HISTORIC PRESERVATION BOARD

---STAFF REPORT---

December 19, 2017

Midtown Delray (2017-284): A Class V site plan application for Midtown Delray that includes 39,396 square feet of retail; 11,117 square feet of restaurant; 55,218 square feet of office; 45 dwelling units; and 39 residential-type inn units. The project also includes the relocation of seven of the existing contributing buildings, reconstruction of one existing building, and demolition of two buildings. The relocation of six of the contributing buildings will occur on Block 61 along Swinton Avenue. Another contributing building will be relocated from Block 61 to the Sundry House property.

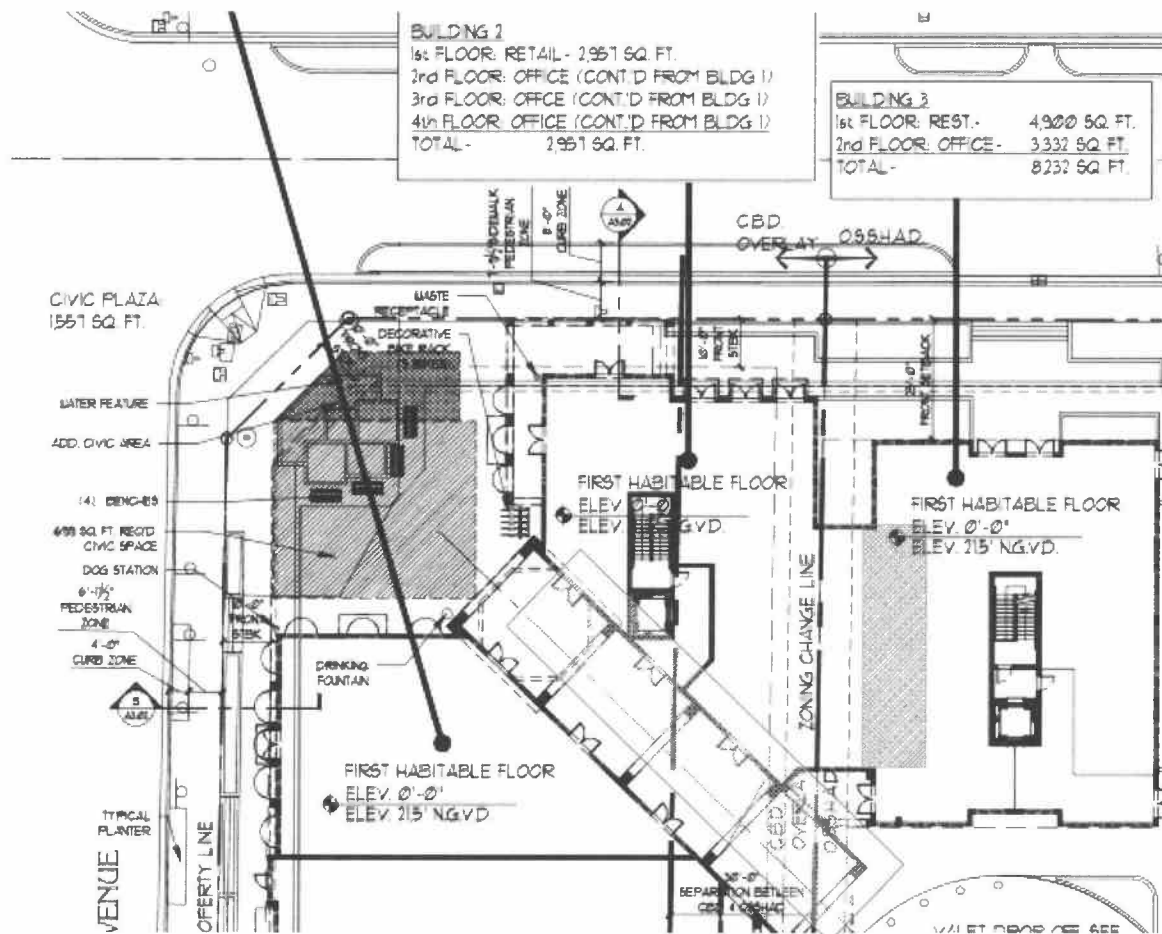
Per LDR Section 4.4.24(F)(4), the maximum width of a building fronting a street shall be limited to 60' and shall have a minimum separation of 15' between buildings fronting a street in a development site that contains more than one structure. The two Residential-type Inn buildings along SW 1st Avenue, the Inn building along Swinton Avenue (building #3), and the Inn building at the southeast corner of Swinton Avenue and SE 1st Street exceed the 60-foot maximum.

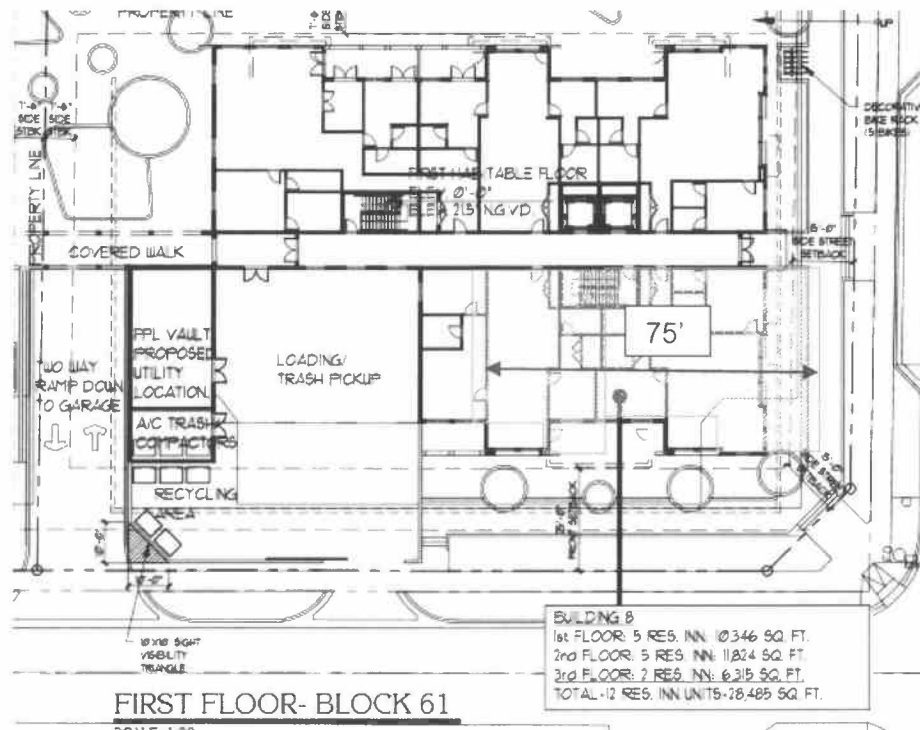
Block 61, Building 8 provides many of the necessary functional aspects of the Midtown Delray Project, which necessitates an additional seventy-six (76) feet in building width along S.W. First Avenue and forty (40) feet along S.W. First Street. Twelve (12) residential inn units comprise Building 8. It also houses a receiving, loading, and air conditioned and acoustically isolated solid waste area that has direct access to SW 1st Avenue and whose street frontage consumes fifty (50) feet and three (3) inches. A recycling area consumes an additional twenty-one (21) feet and one (1) inch of street frontage. These project logistics have resulted in a façade that is broken up to reduce the continuous length and relieve the visual length the actual dimension suggests. Similarly, the overhead FPL electric lines that run through the center of the property will be

reworked to underground facilities, which requires an electrical vault that is shown within Building 8 on Sheet A1.02 of the site plan.

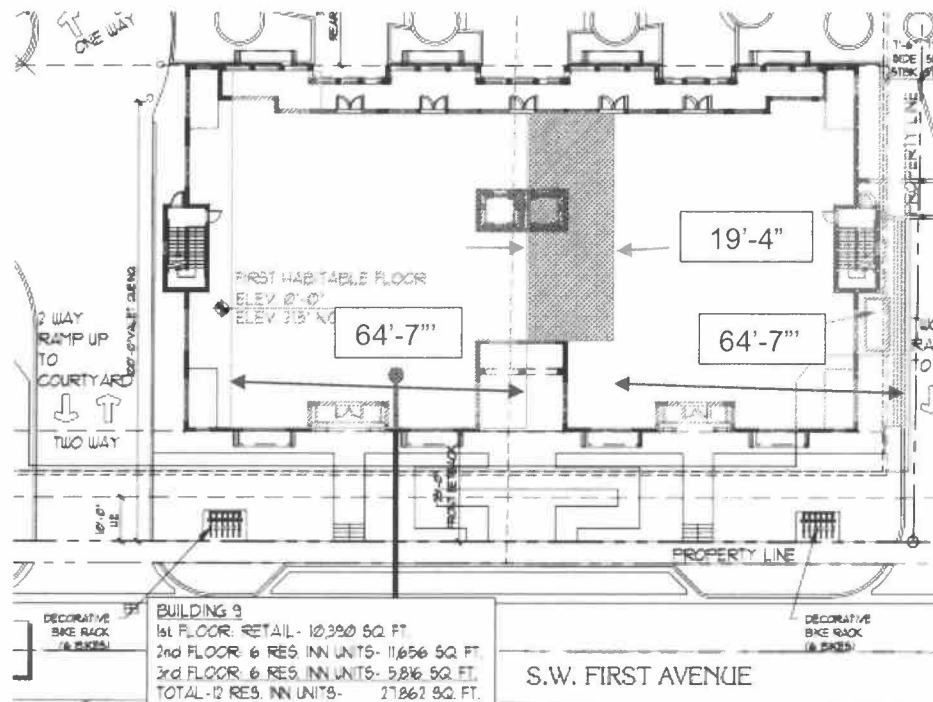
Block 61, Building 9 requires an additional one hundred and four (104) feet in building width in order to provide first floor retail and an additional twelve (12) residential inn units. In order to create a more visual separation in the façade, an additional fifteen (15) foot recess and nearly a twenty (20) foot gap has been added to the middle of Building 9 with landscaping buffers. The main central entry has been eliminated in favor of two entries in the north and south wings. These sixty-five foot wings are connected by the elevator and stairway elements that are stepped back even more on the second and third floors to accommodate upper story planted roofs and a green-wall system. The roof line changes from a sloped roof to a flat roof above the center connection core that further presents the building as two connected facades rather than one long façade.

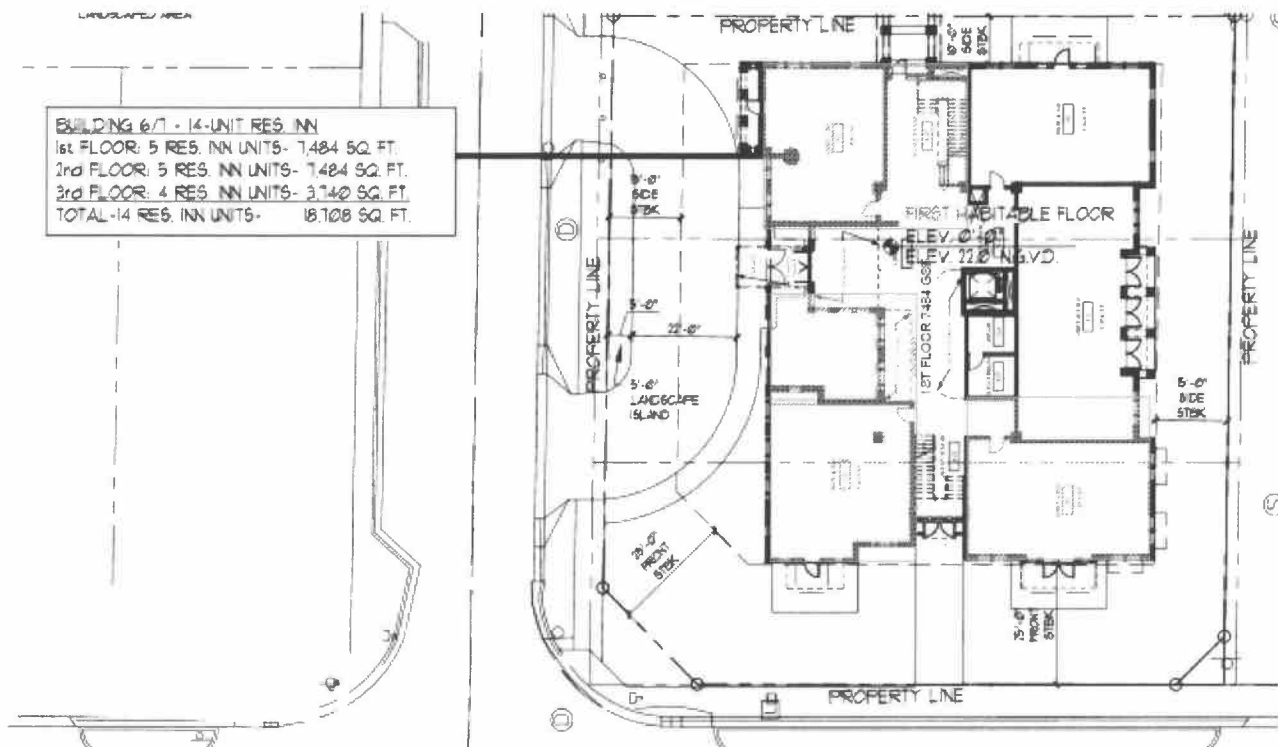
Block 70, Building 6/7 requires an additional forty-four (44) feet and four (4) inches in building width along SE First Street and twenty-one (21) feet and seven (7) inches along South Swinton Avenue in order to accommodate fourteen (14) residential inn units and to integrate the building with the Sundy House. The extension of the overall building beyond the sixty (60) foot façade lengths compensates for the reduction of the permitted three-story building along South Swinton Avenue down to two stories to better transition with the residential along the street and the Sundy House to the west. This is further emphasized with the zoning of the masses separated by the entry facing SE First Street and the stair entry facing South Swinton Avenue.

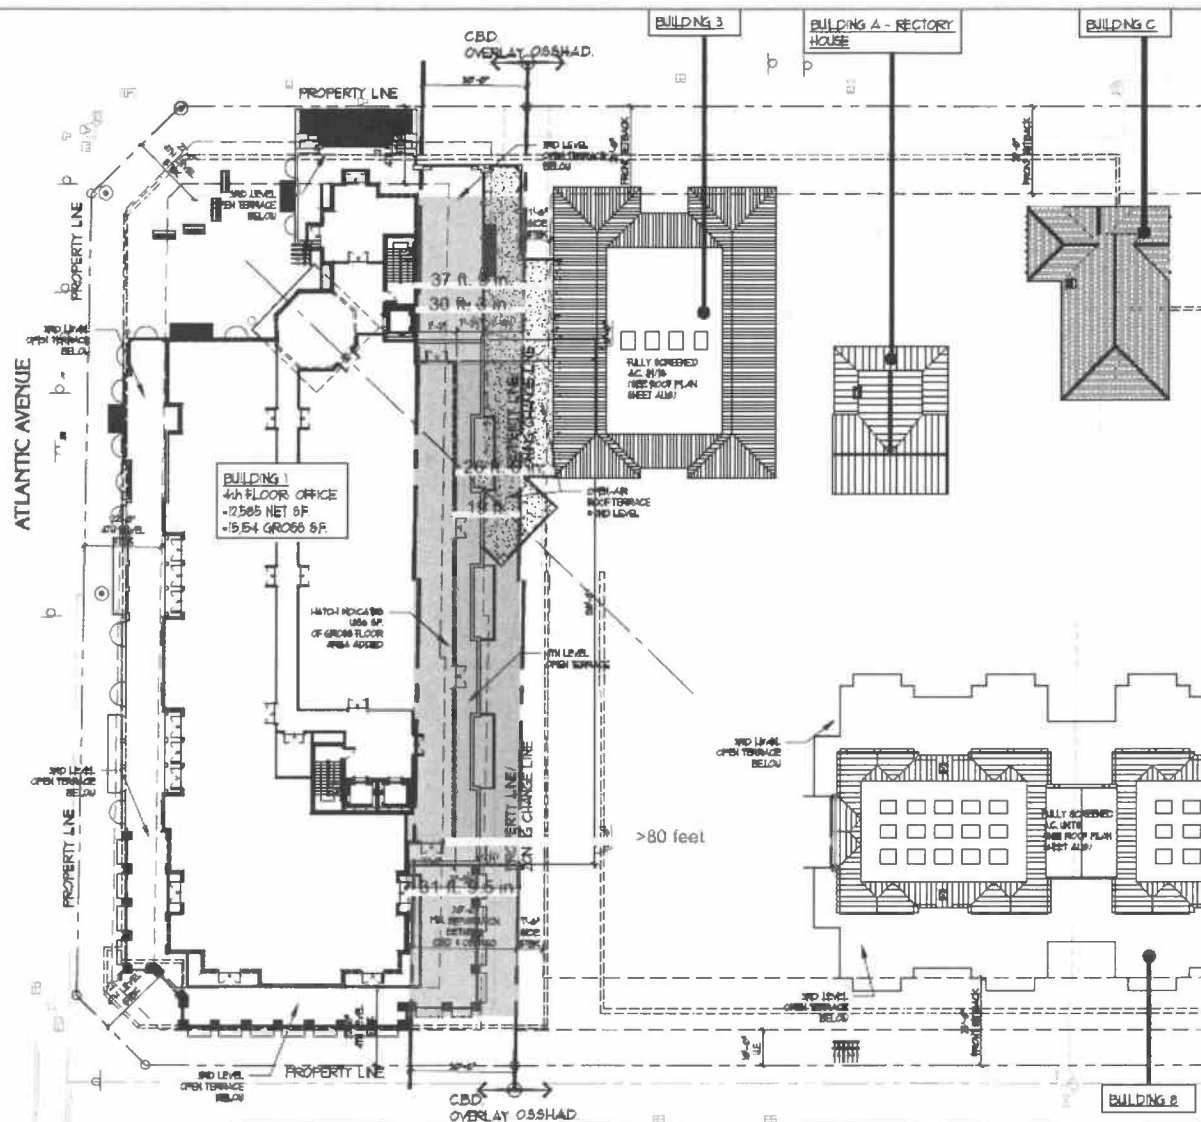
LDR Section 4.6.4(A)(1) is applicable to properties subject to the development standards of the CBD. In this case, Buildings 1 and 2 on Block 61 are subject to the development standards of the CBD and abut an OSSHAD zoned district. LDR Section 4.6.4(A)(1)(a)(ii) requires a minimum thirty (30) foot rear setback if the property abuts a zoning district with a height limitation of thirty-five (35) feet and if the building exceeds three (3) stories in height. Here, Buildings 1 and 2 abut OSSHAD, which limits building heights to thirty-five (35) feet, and Building 1 exceeds three (3) stories in height. Therefore, this code provision requires a thirty (30) foot rear setback for Building 1. Additionally, LDR Section 4.6.4(A)(1)(a)(ii) also provides that the rear setback is measured from the property line to the top of the third story. The Applicant proposes the following: (see illustrations below)

<u>Block</u>	<u>Building</u>	<u>Minimum Rear Setback Required</u>	<u>Proposed Rear Setback</u>
61	1	30 feet	19 feet for a portion of Building 1 from the top of the third floor to the property line only (Approx. 138 feet only) The remainder of Building 1 complies with the 30 foot minimum rear setback.

The intent of this code provision is to create a visual separation between the height differentials of the CBD and OSSHAD zoning districts. The Applicant still meets the intent of the Code despite the proposed waiver request. On the southwest façade of Building 1, there is a significant distance separation (approximately over eighty (80) feet) between Building 1 in CBD and Building 9 in OSSHAD, which achieves the visual separation in excess of the minimum required. On the southeastern portion of the façade, there is a distance separation (approximately thirty-seven (37) feet and nine (9) inches) between Building 1 in CBD and Building 3 in OSSHAD, which also achieves the visual separation in excess of the minimum required. It is also important to note that the areas of Building 1 that do comply with the minimum rear setback are also the areas that are most visible from the adjacent right-of-ways. Therefore, the maximum amount of visual separation is achieved if the requested waiver is granted. Finally, the requested waiver is the minimum necessary to achieve the best site design and reasonable use of the property while balancing the interests of the community. As such, the Applicant respectfully requests that the waiver be granted because the proposed site design still meets the intent of this code provision.
